ISO
14229-1

AMENDMENT 1
2022-10

**Road vehicles — Unified diagnostic
services (UDS) —**

AMENDMENT 1

D.2.1,

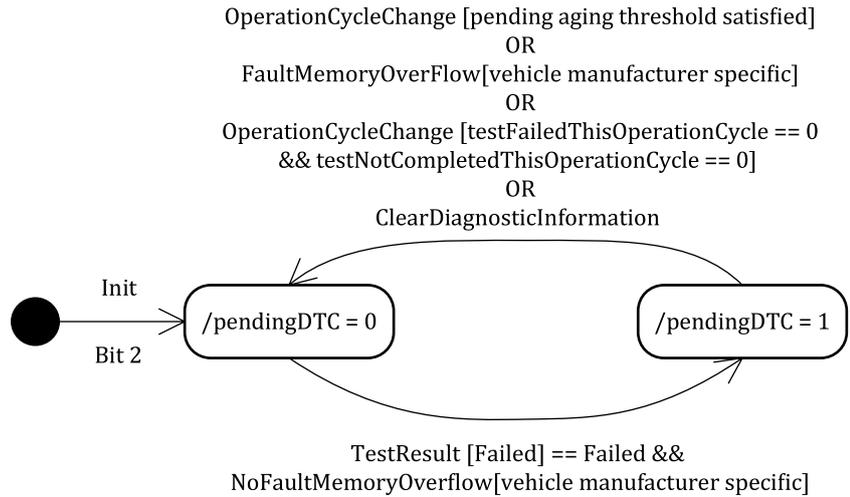
Replace the list item:

- **Confirmation Threshold:** The confirmed status of a failure is defined as a test having reported 'Failed' for this test for a given number of operation cycles where the test has run to completion. Typically for non-OBD use cases the threshold for operation cycles is defined as one. For OBD use cases this threshold is typically greater than one. Implementations may use a Trip Counter (see Figure D.9) as a trigger for changing the confirmed status from 0 to 1. The Trip Counter counts the number of operation cycles (driving cycles) where a malfunction occurred. If the counter reaches the threshold (e.g. 2 driving cycles) the confirmed bit changes from 0 to 1.

with the following:

- **Confirmation Threshold:** The confirmed status of a failure is defined as a test having reported 'Failed' for a given number of operation cycles where the test has run to completion. Typically for non-OBD use cases the confirmation threshold for operation cycles is defined as zero. For OBD use cases this confirmation threshold is typically greater or equal than one. Implementations may use a trip counter (see Figure D.9) as a trigger for changing the confirmed status from 0 to 1. The trip counter is incremented at the end of an operation cycle if testFailedThisOperationCycle is 1 and counts the number of completed operation cycles where a malfunction occurred. If test result reported a value of "failed" and the trip counter has reached the confirmation threshold, then the confirmed bit changes from 0 to 1.

D.2.3, Figure D.4

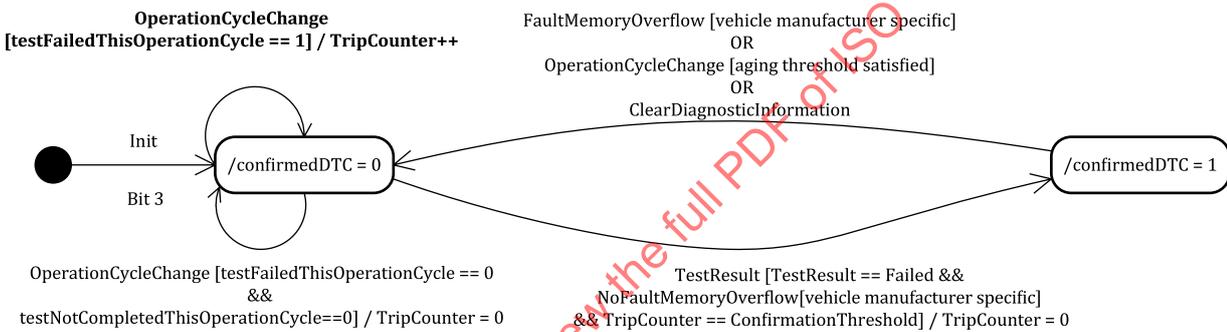
Replace Figure D.4 with the following:

D.2.4, Figure D.9

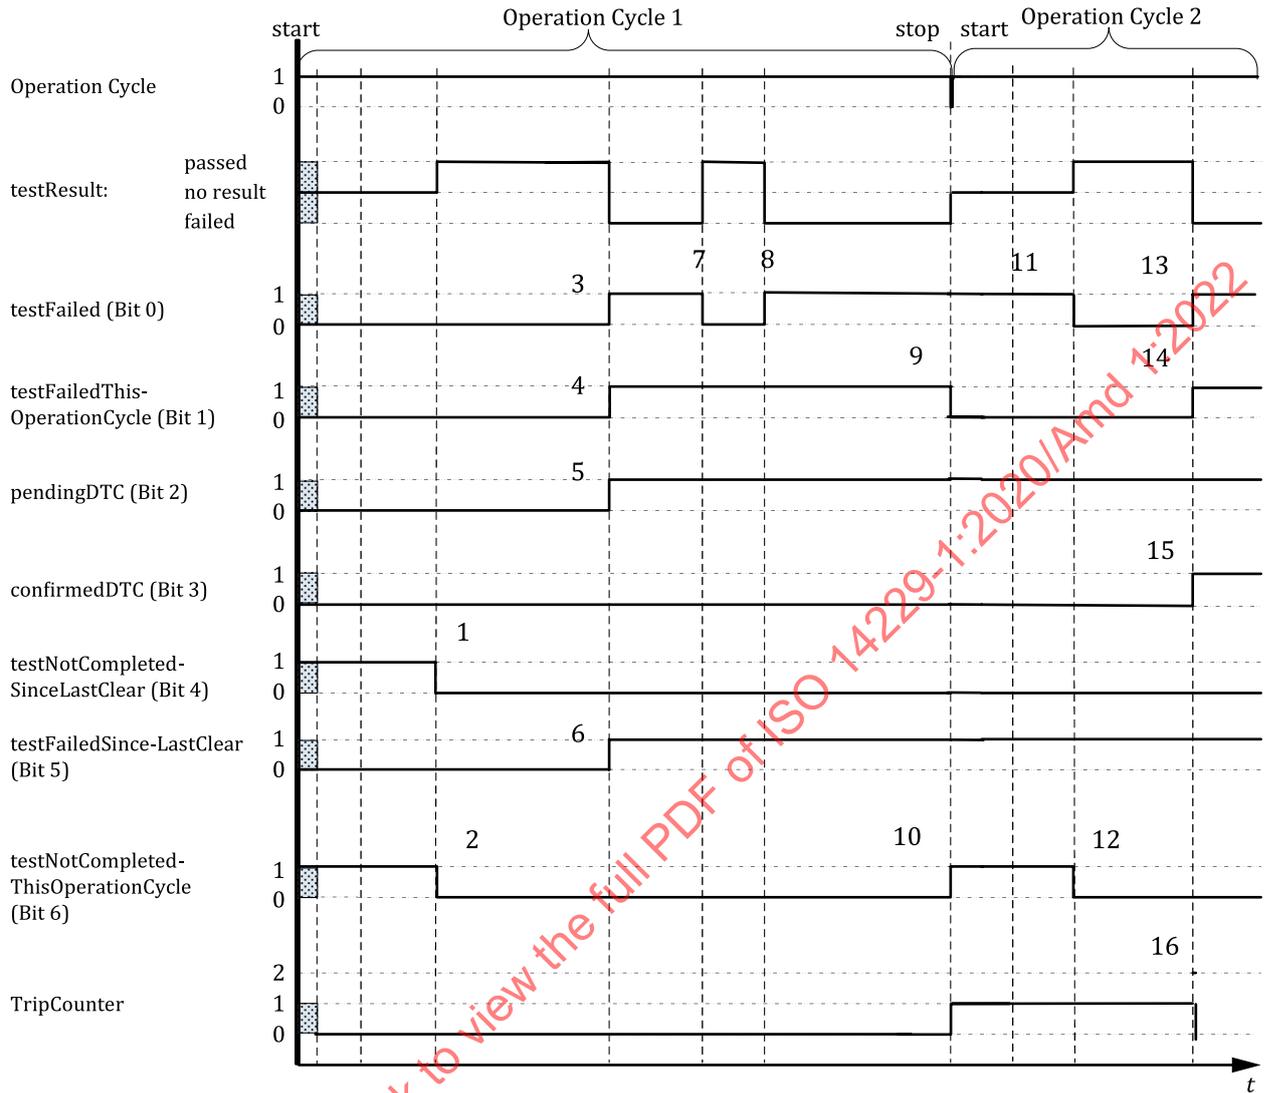
Replace Figure D.9 with the following:

Replace description of key 16 with "TripCounter is reset to '0' when the DTC status changes to confirmedDTC according to Figure D.4."

D.6, Figure D.10

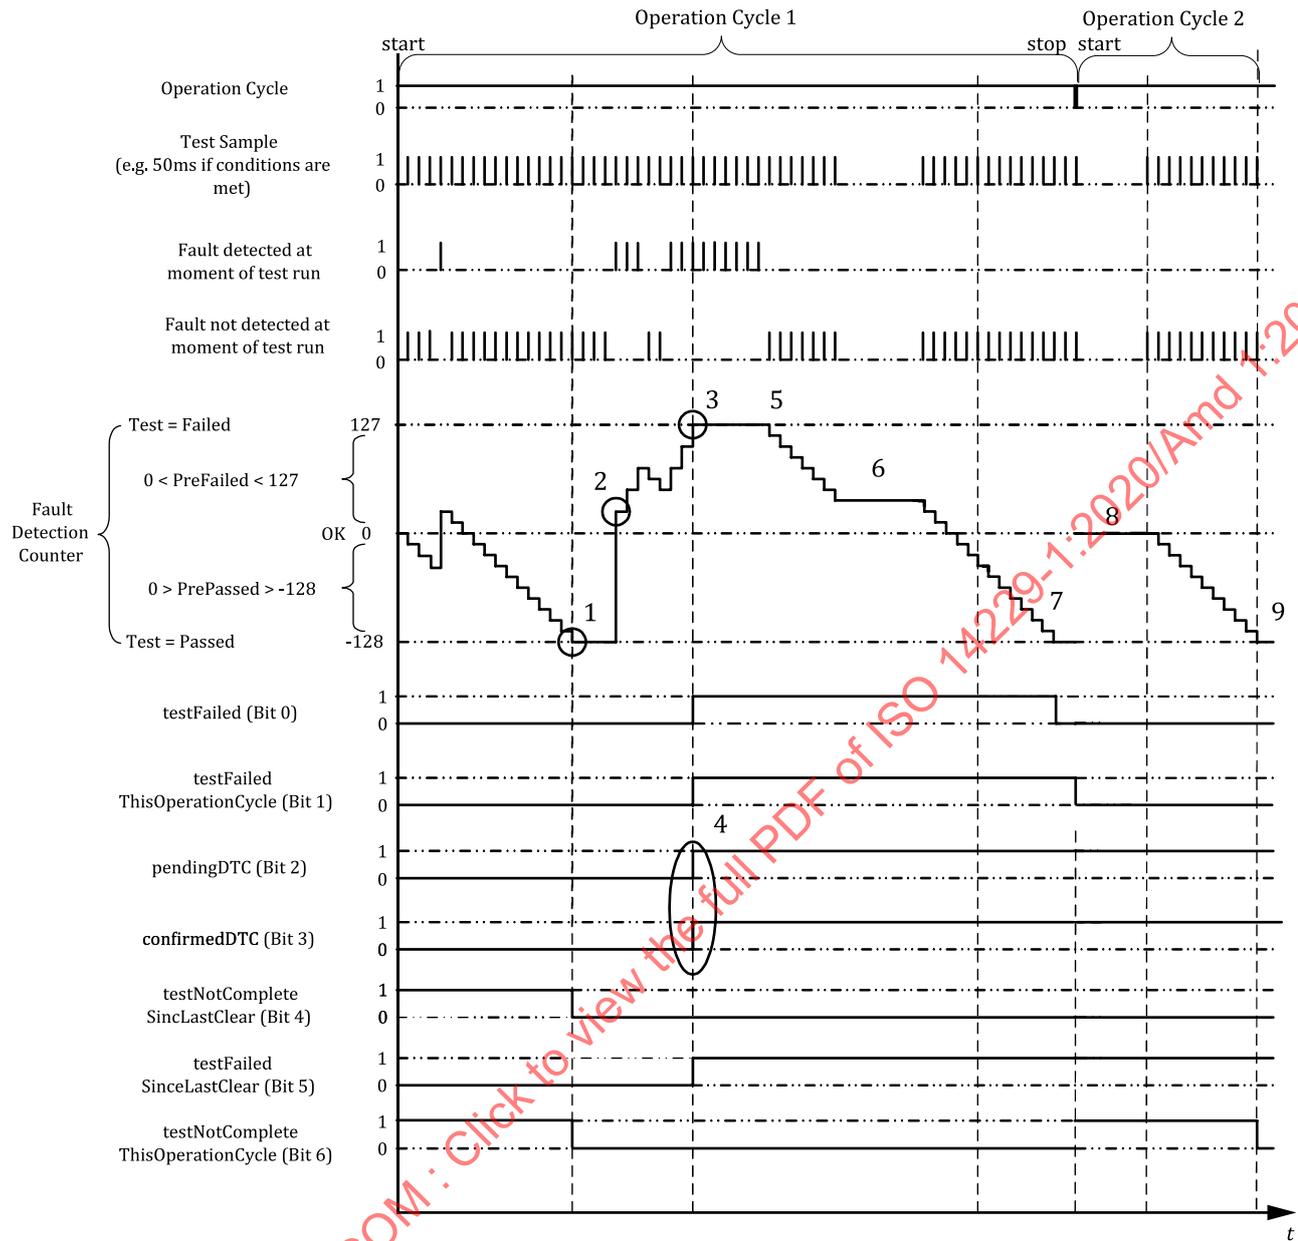
Replace Figure D.10 with the following:
